TENNESSEE VALLEY AUTHORITY

RESPONSE TO THOMAS M. NOVAK'S SEPTEMBER 17, 1982 LETTER
TO H. G. PARRIS REQUESTING ADDITIONAL INFORMATION
ON HYDROGEN CONTROL FOR ICE CONDENSER PLANTS

SEQUOYAH NUCLEAR PLANT

RESPONSE TO
REQUEST FOR ADDITIONAL INFORMATION
ON HYDROGEN CONTROL FOR ICE CONDENSER PLANTS

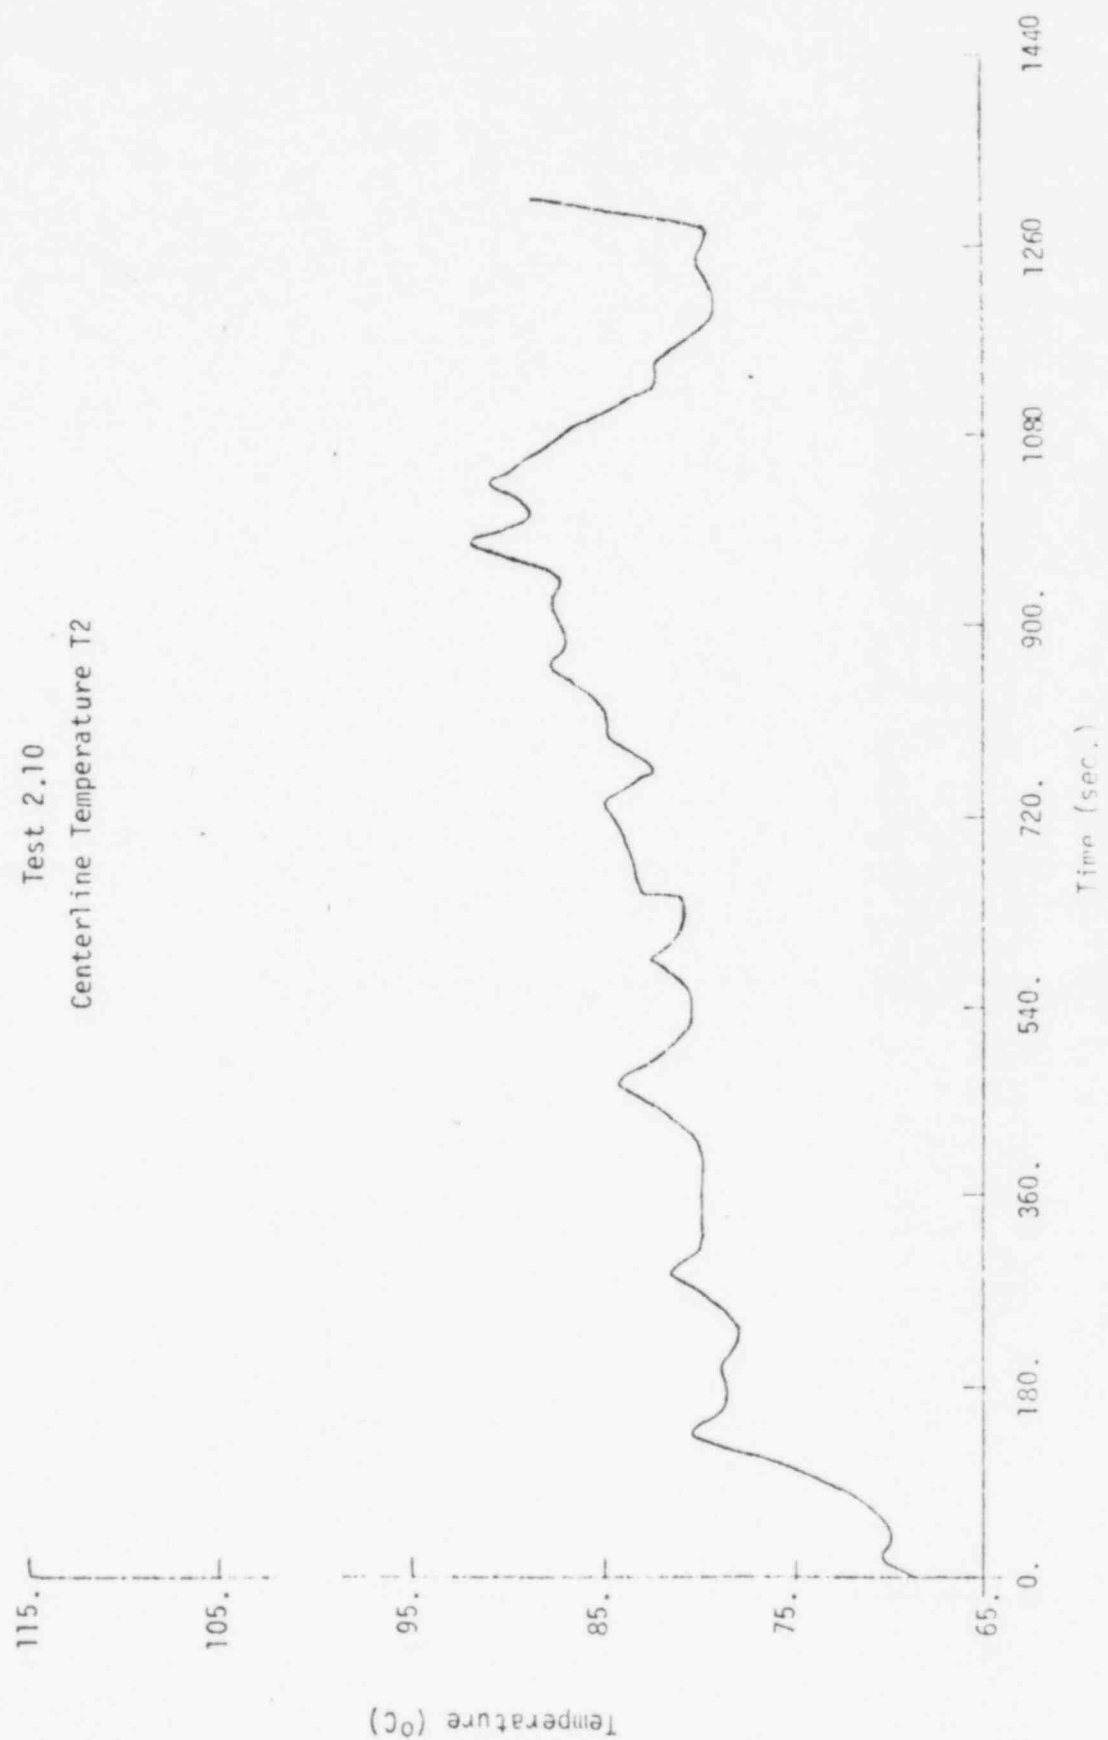
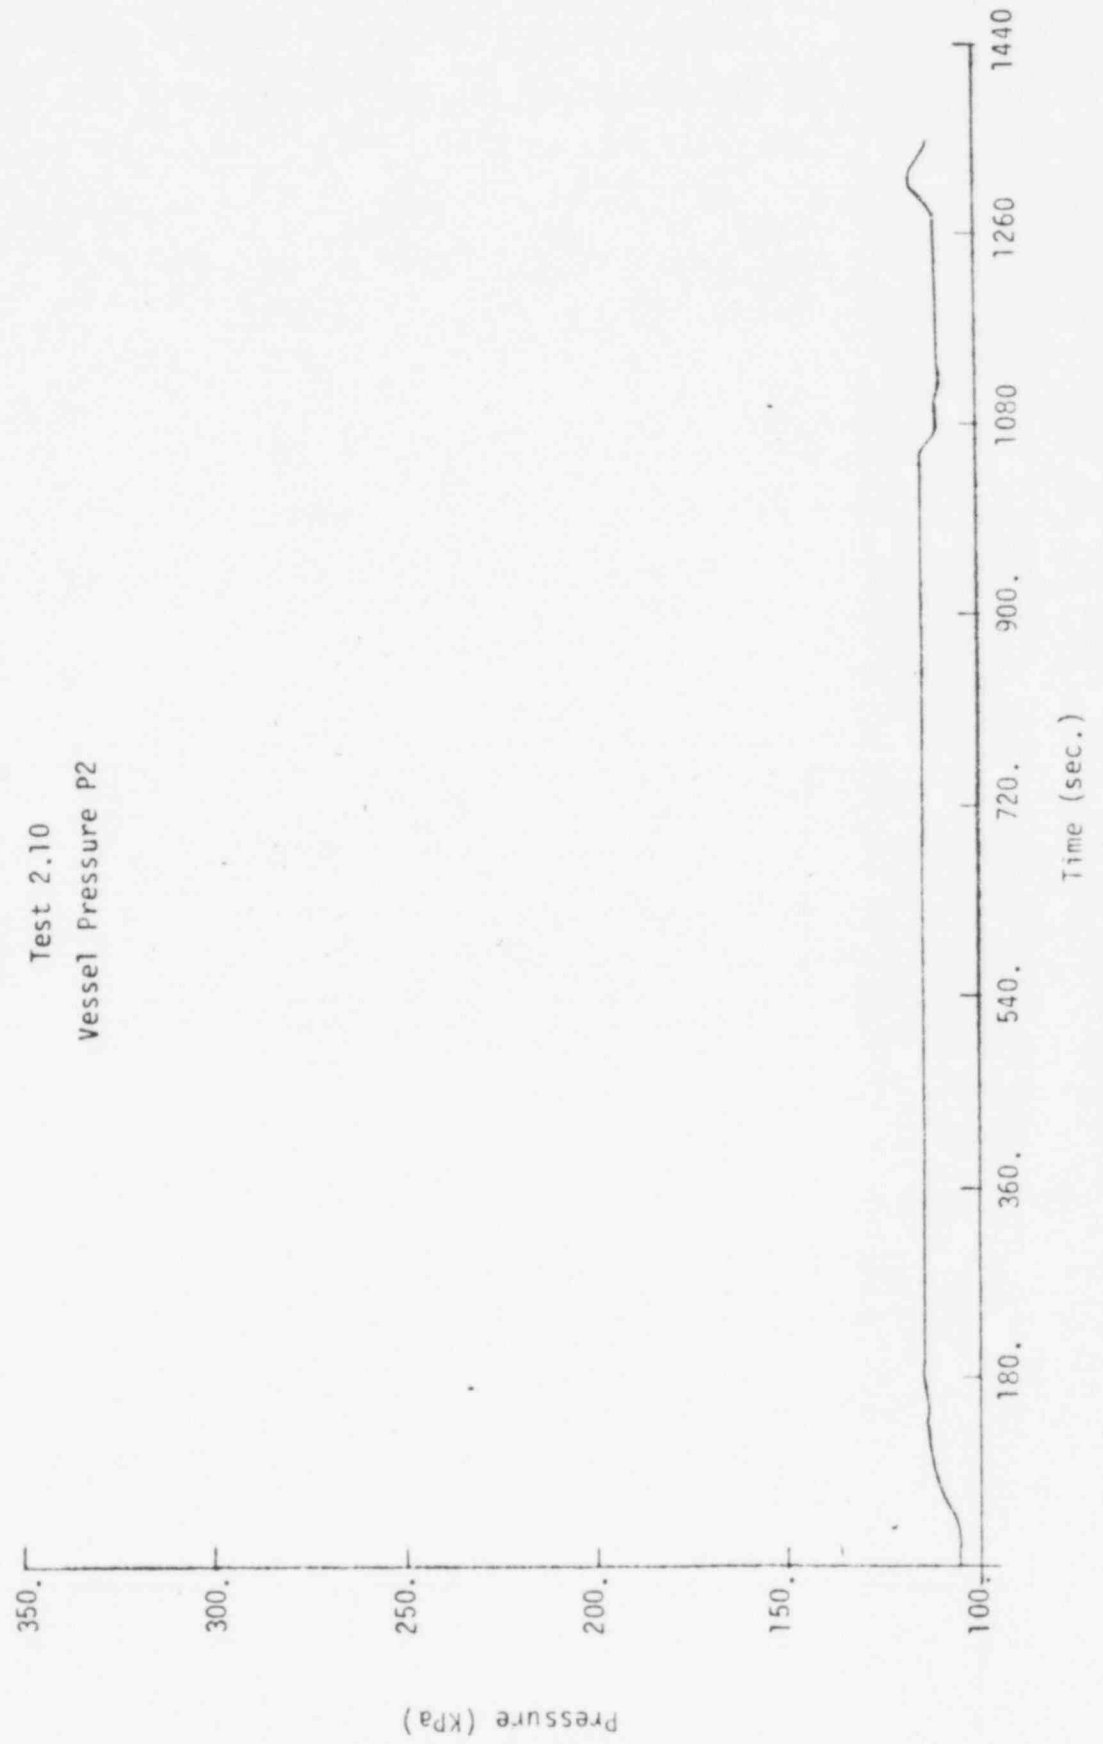
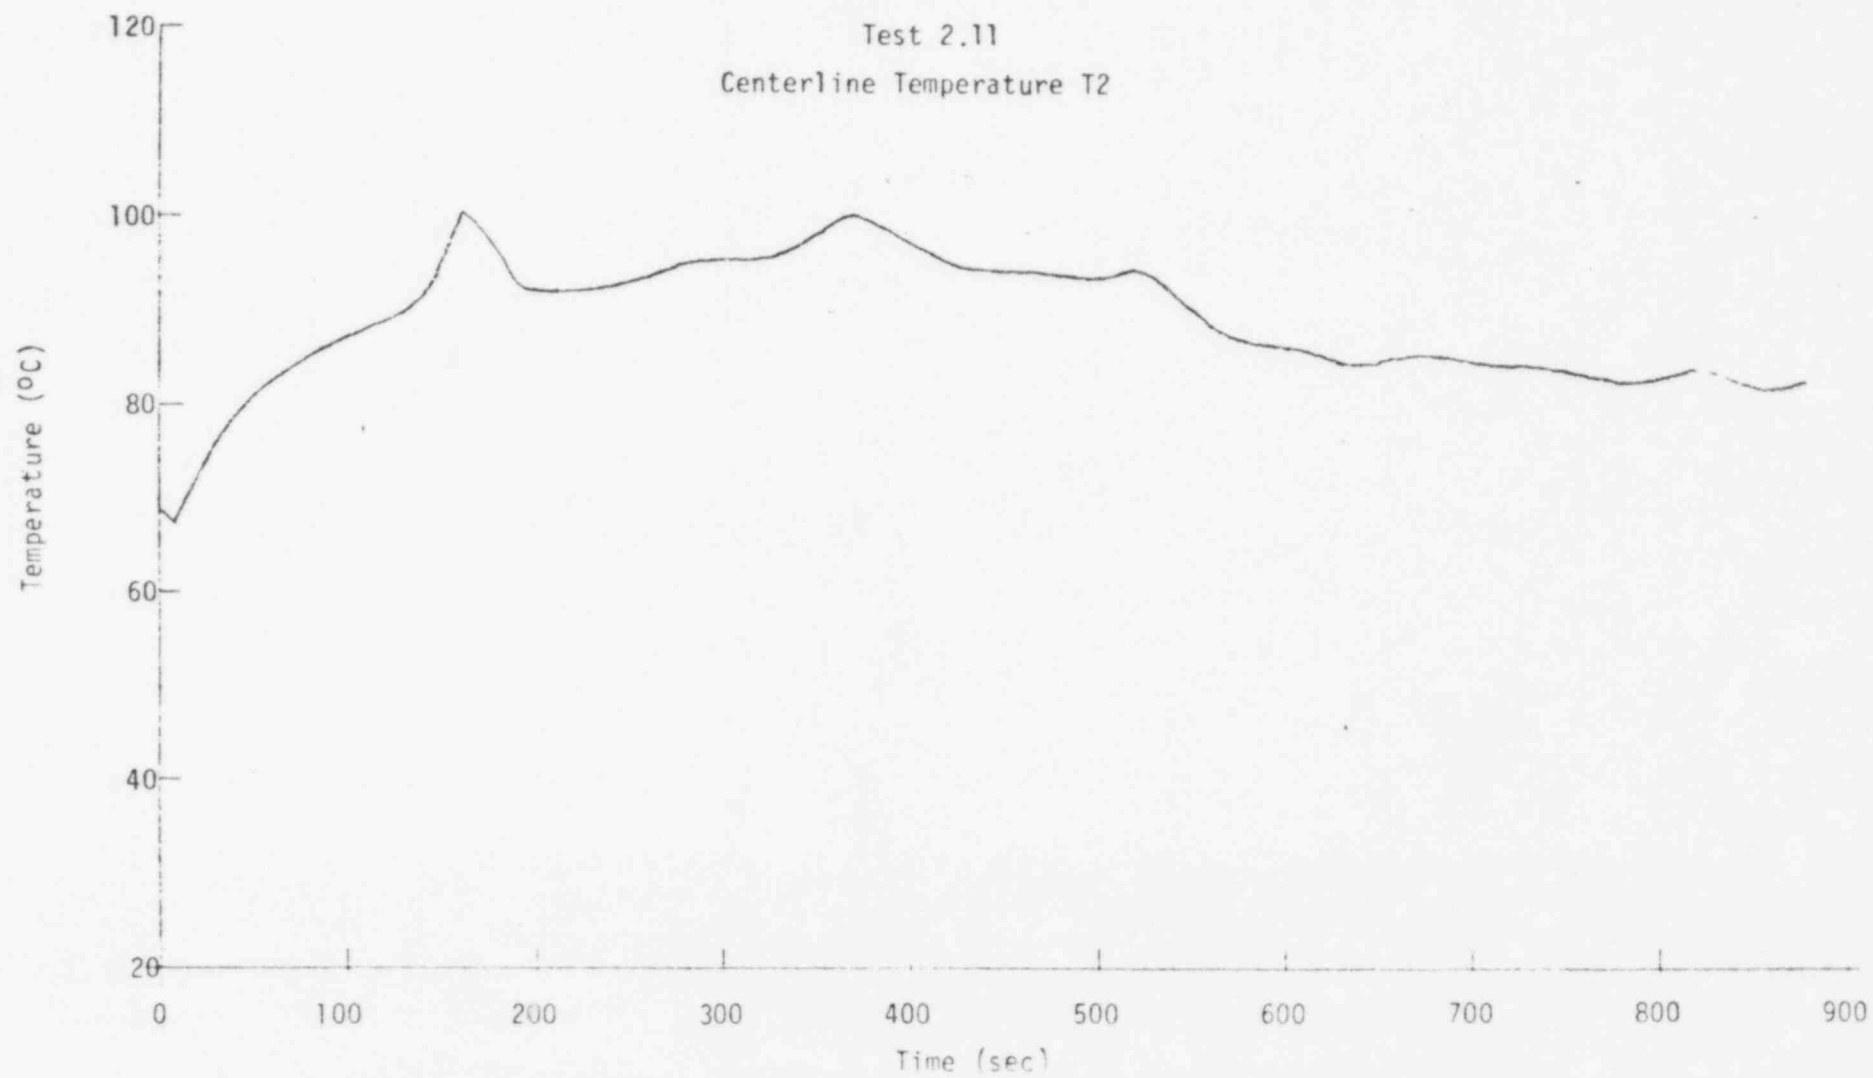
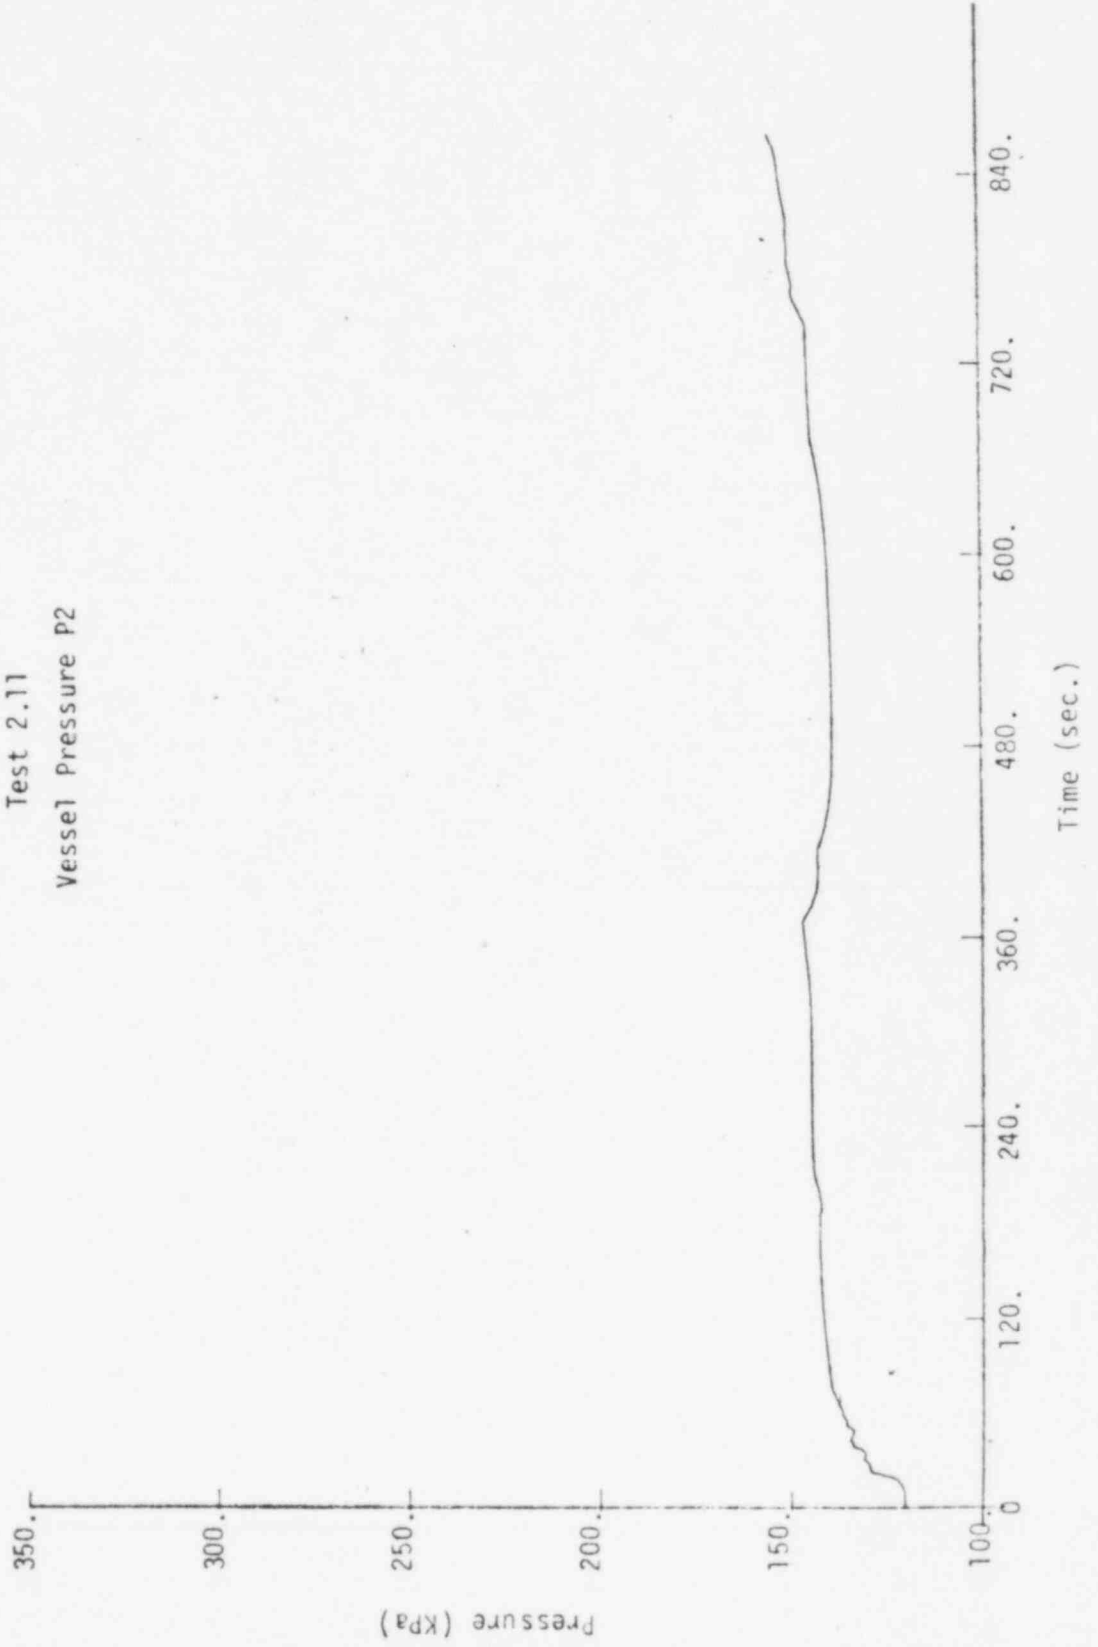
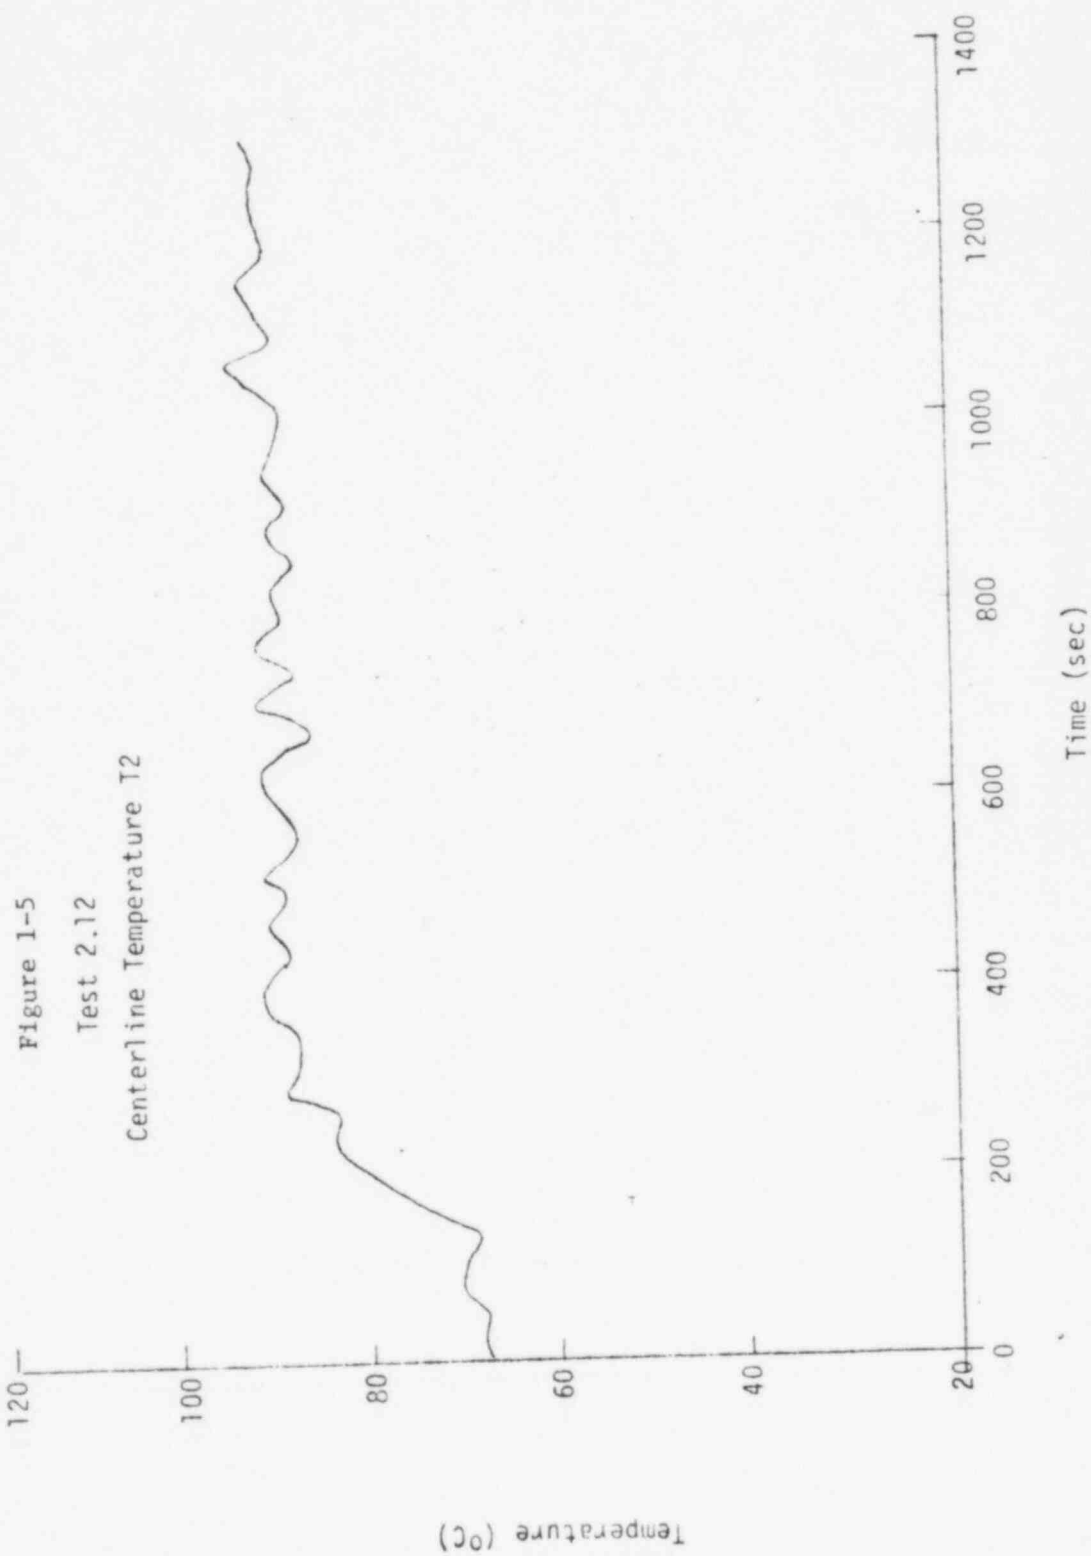
- i) A table of droplet size and droplet density estimates for each of the fog/spray tests.
- ii) A table of estimated flame speed for each test (flame speed should be calculable from thermocouple locations and ignition time data).
- iii) Pressure and temperature traces similar to those depicted in Figures 4-2 of the December 1981 Acurex Project Report, but for tests 2.10, 2.11, and 2.12.
